FUEL FILL NECK REPAIR

Bulletin Type:	SRP	Publication Date:	March 2024
Bulletin #(s):	24-007	Make(s):	Jayco, Entegra Coach
Job Code(s):	<i>If affected unit has warranty remaining, submit your claim following the normal process</i>	Model(s):	Seneca Prestige (37K), Accolade XL (37K)
Flat Rate(s):		Model Year(s):	2024

Incident:	Fuel tank is slow filling, cannot use the fuel pump nozzle at high or full volume due to restriction in fuel hose under ABS tank drain pipe.
Affected Units:	2024 Jayco Seneca Prestige; 2024 Entegra Coach Accolade XL
Parts List:	N/A
Misc. Tools & Supplies:	compact saber saw or dremel tool, water proof foam

Fig. 2

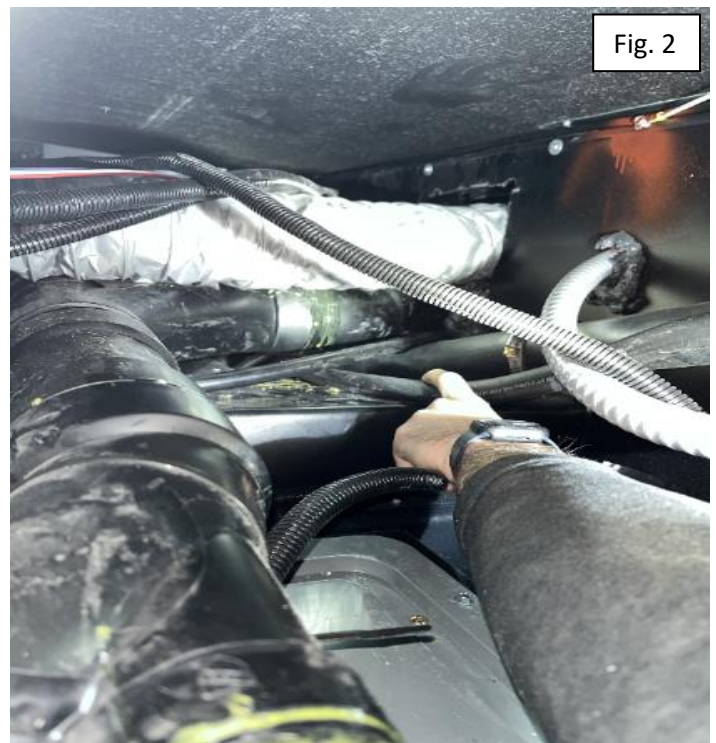
2. Find and relocate any wires or lines behind white water control board to prepare the plastic tub area for cutting. (Figure 2)
3. Using a narrow compact saber saw or dremel tool.
 - a. Cut slits/lines in the tub on both sides parallel with the hose, far enough to allow the tub and hose to settle down below the ABS drain pipe. (Shown in figure 3 and 4 by red parallel lines)
 - i. **Note:** Do not remove any part of the tub that has been cut for a better

Fig. 3

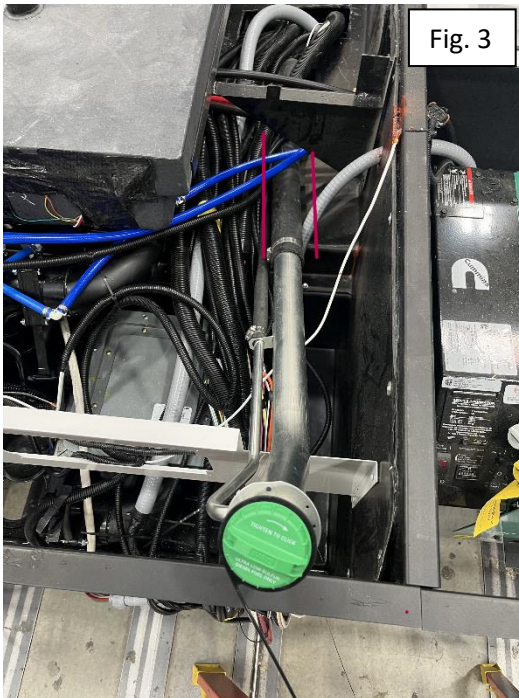
seal at the end of the modification. Do not remove the tub or any material.

- b. Seal the slits/lines in the tub with a waterproof foam sealer when the modification is completed.
